**Re: NMOCD Case No. 15442: Application of BC Operating, Inc. for
Authorization to Inject, Eddy County, New Mexico**

RE: Case No. 15442; Submitted Statement of the State Land Office

From: Holm, Anchor [mailto:aholm@slo.state.nm.us]
Sent: Thursday, March 17, 2016 9:55 AM
To: Goetze, Phillip, EMNRD <Phillip.Goetze@state.nm.us>
Cc: Martin, Ed <emartin@slo.state.nm.us>; Warnell, Terry G. <twarnell@slo.state.nm.us>
Subject: BC Operating - Grande State #1 SWD Proposed Plugback

Proposed Injection

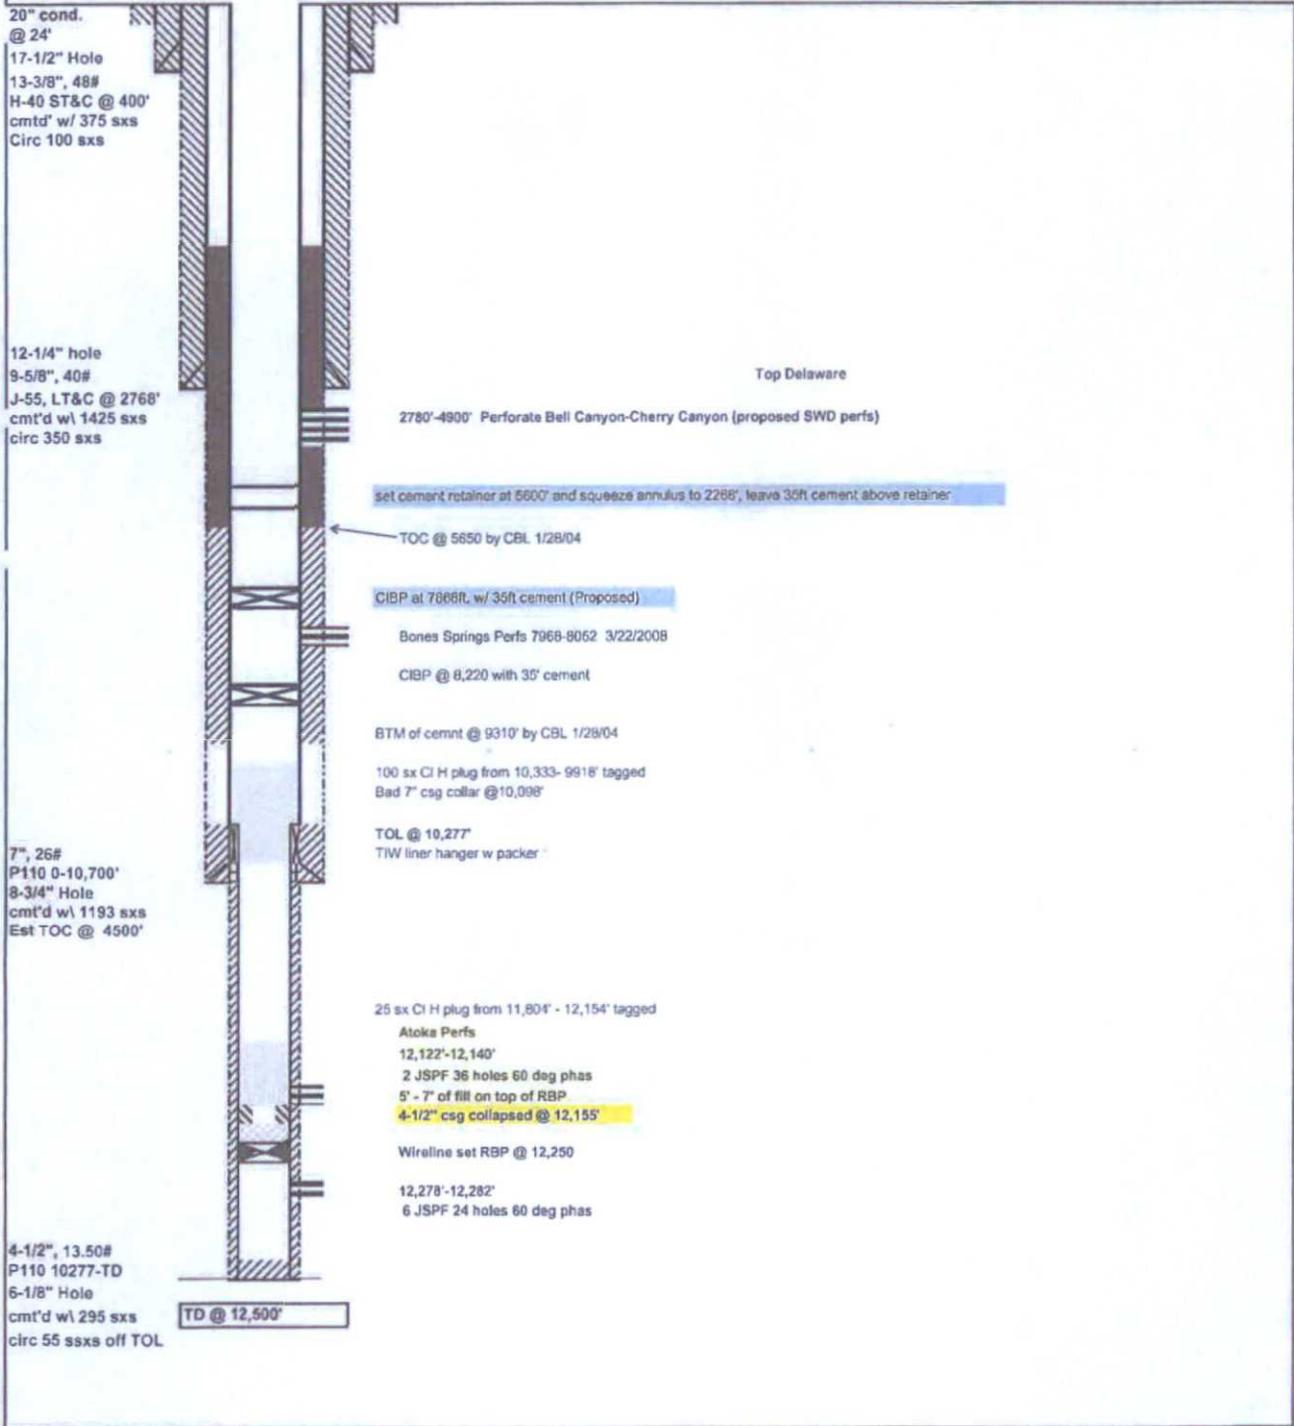
Yesterday, I received the revised copy of the C-108 SWD Application for the Grande State #1 (30-015-31910) by BC Operating. Their Proposed SWD interval is from 2,780' to 4,900'. In this wellbore the bottom of salt was recorded at a depth of 2600', which must be protected from solution by disposed produced waters. Typically, a minimum buffer of at least 300 feet is desired by the State Land Office in order to protect the surface Trust Lands from potential subsidence caused by salt water disposal.

Therefore, the State Land Office recommends that the top of injection be lowered to a depth of at least 2,900'. Also, in the well located on the same lease about ½ mile east of the proposed SWD, the bottom of salt was reported at 2,775'. This suggests that a top of injection of 3,075' may be more prudent.

An additional concern is the construction of the Grande State #1 wellbore. It did not have the annulus outside the 7" casing cemented above 5,650'. The 9-7/8" surface casing was set at 2,768', only a short distance below the bottom of Salt reported in the subject wellbore. However, the offset well having a top of salt reported at 2,775', which is deeper than the surface casing setting depth in the Grande State #1 wellbore.

Therefore, the State Land Office recommends that the proposed cement squeeze of this annulus be modified from a target top of cement at a depth of 2,266' to a requirement to **circulate cement to surface**. The reasoning is that the cement job at the shoe of the surface casings in this area frequently do not fully protect the salt from being dissolved by SWD operations. By placing additional hydraulic head on the surface casing shoe during the squeeze cement job, the strength of the seal at the shoe will be significantly improved.
